Flight Procedures Cover Page	Task Action: Abbreviated Amendment	Task Type: IAP	Estimated Chart Date: 03/19/2026	APWS Task ID: 6CBFCA53719F411F8CB53E71E472F2AF	APWS Project ID: 664F53B9AF7447A99FD18313085C6B79
Procedure: RNAV (GPS) RWY 5 AMDT 0D		Enroute: NO	Specialist: Ferreira, Giorgia		Agreement Number:
Airport ID: 99N			Airport City: BAMBERG		State: SC
Facility ID:	Facility Type:	Flight Inspection Remark Type:

RNAV (GPS) RWY 5

BAMBERG COUNTY (99N)

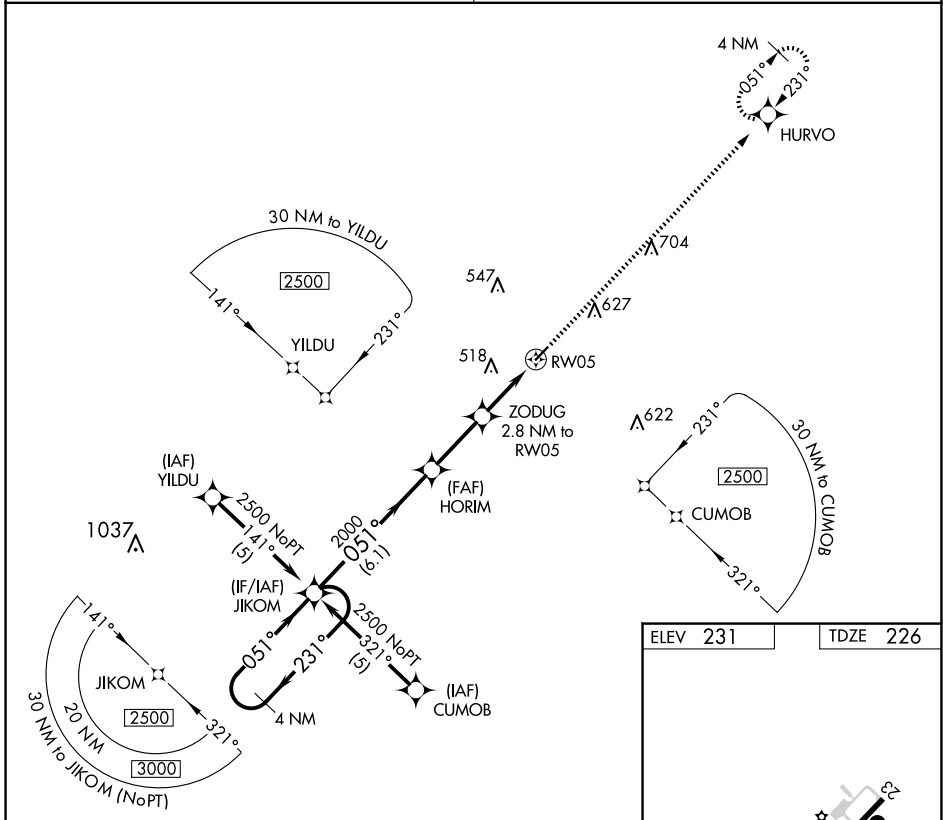
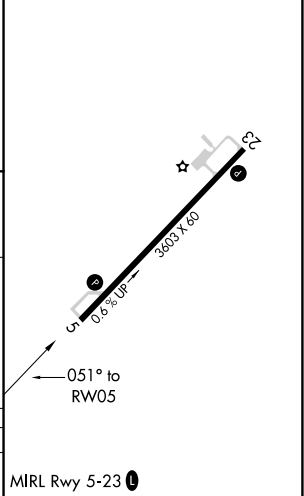
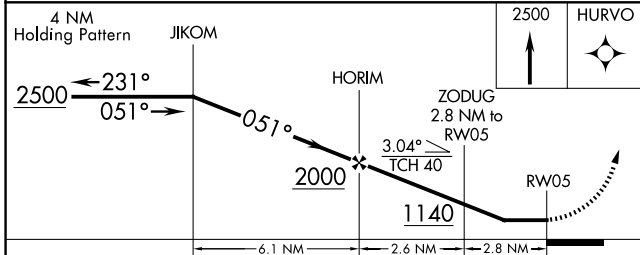
INCORPORATED CHANGES FROM NOTAM: !FDC 5/8991 99N IAP BAMBERG COUNTY, BAMBERG, SC. RNAV (GPS) RWY 5, ORIG-C... DISREGARD DESCENT ANGLE 3.04/TCH 40. PROFILE NOTE: VISUAL SEGMENT - OBSTACLES. 2504211151-2705211145EST.

01/29/2026: THIS IS A CORRECTED COPY OF THE FORM APPROVED ON 01/07/2026.
 TERMINAL ROUTES: REMOVED RNP VALUE FROM CA LEG.
 ALTIMETER SETTING NOTE: CORRECTED IDENTIFIER FROM OBG TO OGB.

02/02/025: THIS IS A CORRECTED COPY OF THE FORM APPROVED ON 01/07/2026
 CHANGED NOTE: CHANGE CHART OBG ASOS TO CHART OGB ASOS.
